Product Change Notification

Date Issued :	March 09, 2022	PCN Number :	511785
Reason for Change :	Obsolete		
Description of Change :	This notification is to inform you about the Obsolescence of part(s) referenced in this notice. Please connect with your Molex Sales Engineer for additional queries related to possible replacement part(s).		
Reason for Short Notice :	Special Request		
Planned Implementation Date :	July 11, 2022		
Recommended replacement parts :	Please see the attached replacement parts list .xls file.		
Last Time Buy Date for Obsolete Parts :	March 31, 2022		
Last Time Ship Date for Obsolete Parts :	June 30, 2022

- Please be advised that the following Part numbers from the QSFP+/ZQSFP+ Ganged cages product families are being made Obsolete with replacement. The spring fingers of the offered replacement parts will be made of Stainless Steel & will also undergo laser welding during the assembly process.

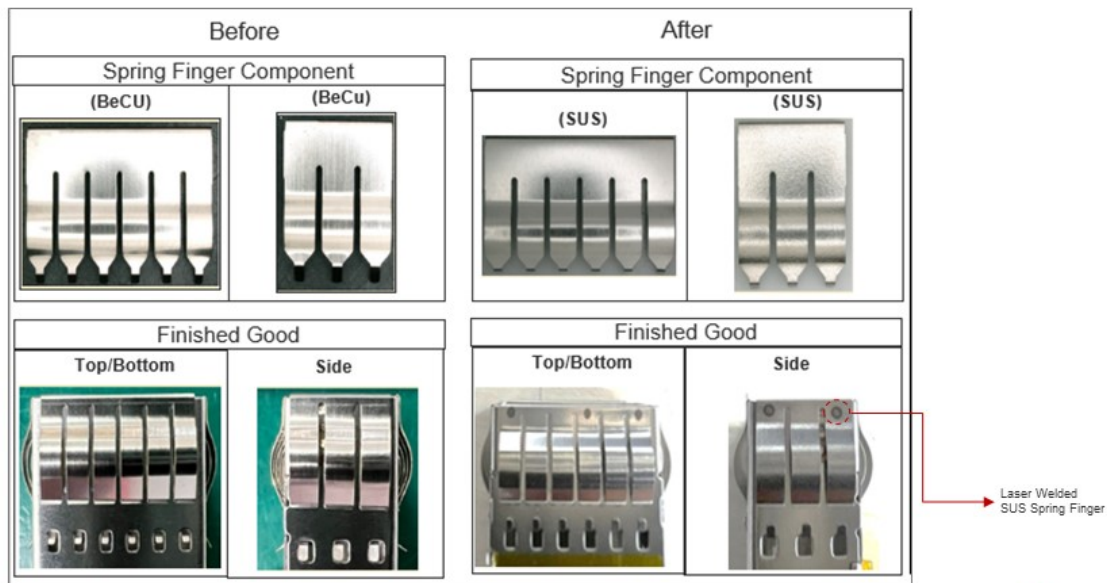
- Reason for Change
Critical shortage of Beryllium Copper which is the raw material used in spring fingers of the affected parts.

- Product Impact
Spot welds will be the only effect to the form, no impact on fit or function based on test summary 1000143001 (available upon request).
